WILLOWTREE PLANNING

RE: DA2025/0764 - REQUEST FOR ADDITIONAL INFORMATION - ALTERATIONS AND ADDITIONS TO LONG REEF GOLF CLUB CLUBHOUSE

PROPERTY AT: 2 ANZAC AVENUE, COLLAROY

Table 1: Response Matrix	
Council Comments	Proponent Response
1. Water Management	
Runoff from stormwater and roof areas is proposed to be directed to an existing pond within the golf course, enabling the reuse of collected water for irrigation. Consideration should be given to the storage capacity of the pond and the quality of water treatment before discharge.	<p>Water management issues raised have been reviewed by a water and flooding engineer who has prepared a response at Appendix 1 which provides as follows:</p> <p>This has been considered. The catchment characteristics for the contributing area that drains to the existing wetlands, catch drains and water harvesting retention ponds established between 1996 and 2018 on the golf course does not change as a function of the proposed development. This does not change the current water quality or quantity of any runoff and as a result we feel that there is no practical need for any additional IWCM modelling to support this DA. Both the golf club clubhouse and

Figure 1 - Extract of NSW Spatial Explorer with NSW SEED Hydrography dataset

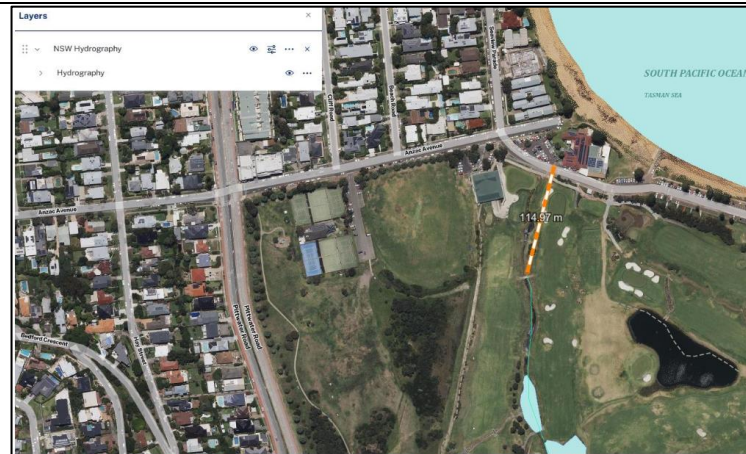
The proposal includes new pipes located within 40 metres of a mapped waterway, as specified in the Water Management (General) Regulation 2018 and the Hydro Line spatial data. Warringah DCP Clause E8 Waterways and Riparian Lands applies to the proposal, and a Waterway Impact Statement (WIS) is required. The proposal must comply with the requirements of the Northern Beaches Council Water Management for Development Policy (WMD Policy), including Table 5 Water Quality Requirements.	As outlined in the response by the water and flooding engineer at Appendix 1 , the NSW Hydrography dataset shows the nearest hydroline is over 40m away from any proposed works. The nearest hydroline in question forms part of the water harvesting, retention and irrigation systems developed over the golf course from 1996 onwards and is known as 'Drain C' which drains into Pond 7 and Pond 2 respectively. Both the golf club clubhouse and the course itself are on the same Lot and DP (Lot 1 in DP1144187) - there is no discharge of any land in the public domain or any other landowner. Refer to the hydrography overlay in figure 1 below and the layout of the water harvesting, retention and irrigation systems present over the golf course playing green in figure 2.

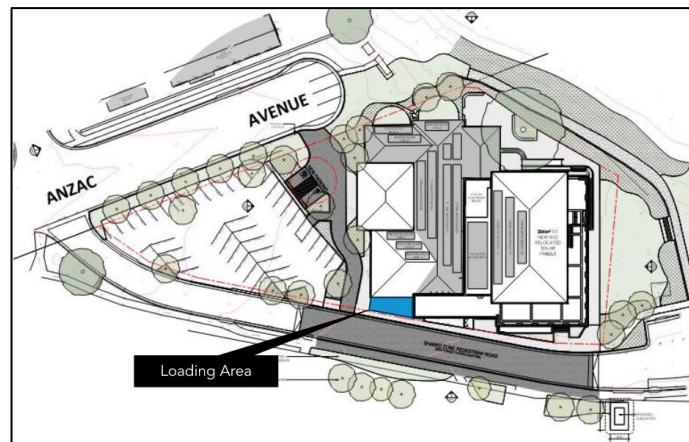
- It remains unclear whether the circulation path on the proposed new vehicle access is also intended to be used as a delivery zone for the back-of-house areas and keg room. Clarification is required.

- It is noted that a loading zone is provided on the southern side of the building, east of the new vehicle access path. However, no information has been provided regarding the dimensions of this loading bay or the size of the largest truck expected to use it. It is also unclear whether trucks will access the loading zone via the new Anzac Avenue access or the proposed shared zone road.

- The submitted traffic report on page 38 states that there are existing multiple loading zone areas and one dedicated car parking space for service vehicles. Further information is required regarding the location of these loading zones and the size of trucks that access them.

- Given the scale of the proposed development, Council does not anticipate deliveries being made by small vehicles but expects larger trucks. Therefore, a dedicated loading bay capable of accommodating at least a 6.4 metre Small Rigid Vehicle (SRV) must be provided.

- Additionally, swept path analysis must be submitted to demonstrate safe access to and from the proposed loading bay.

The loading area is to be retained in the existing location on the southern side of the building as identified in the following extract from the architectural drawings.

<p>The plan retains the current arrangement, which accommodates all deliveries and waste collection and the ability to receive vehicles either front-in for access to the rear doors/waste lift, or reverse-in if required.</p> <p>Swept paths of a 6.4 metre Small Rigid Vehicle accessing the loading area, are included as an attachment to Appendix 6.</p>
